# Access Compliance Report

## Public Rights-of-Way (Curb Ramps)

Intersection ID: 12018	Main Street: S_GRAHAM_ST	Cross Street: W_3RD-4TH_CONNECTOR_ST	Location: N
ADA ID: 01DBAC132E68	Ramp Type: PerpDiag	Initial Pass/Fail: Fail	Overall Compliance: No
			Severity Score: 48.75

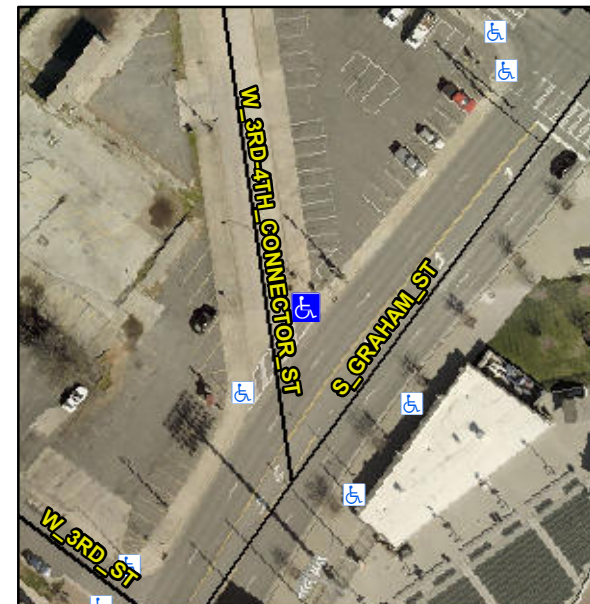
**Not Found, R304.5.1, R304.2.2, R304.5.3**

Compliance	Description	Data	Compliance	Description	Data
N/A	Ramp Length (in)	79.0	No	Ramp Slope (%)	9.3
No	Ramp Width (in)	25.0	No	Ramp XSlope (%)	3.3
N/A	Flare Type LT	N/A	N/A	Flare Type RT	N/A
N/A	Flare Slope LT (%)	N/A	N/A	Flare Slope RT (%)	N/A
N/A	Flare Traversable LT?	N/A	N/A	Flare Traversable RT?	N/A
N/A	Landing Length (in)	N/A	N/A	DWS Provided?	N/A
N/A	Landing Width (in)	N/A	N/A	DWS Contrast?	N/A
N/A	Landing Slope (%)	N/A	N/A	DWS Length (in)	N/A
N/A	Landing X Slope (%)	N/A	N/A	DWS Full Width?	N/A
N/A	Landing Curb? (Y/N)	N/A	N/A	DWS Offset (in)	N/A
N/A	Shared Landing?	N/A			
N/A	Gutter Ponding?	N/A	N/A	Gutter Slope (%)	N/A
N/A	Gutter Lip Ht (in)	N/A	N/A	Gutter X Slope (%)	N/A
N/A	Painted X Walk1?	Yes	N/A	Painted X Walk2?	No
	X Walk 1 Direction	To SW		X Walk 2 Direction	To SE
N/A	X Walk 1 Width (in)	109.0	N/A	X Walk 2 Width (in)	N/A
	X Walk 1 Slope (%)	0.1		X Walk 2 Slope (%)	2.5
	X Walk 1 X Slope (%)	0.9		X Walk 2 X Slope (%)	1.5

**Remove & Replace Curb Ramp With Two New Directional Ramps or Equivalent.**
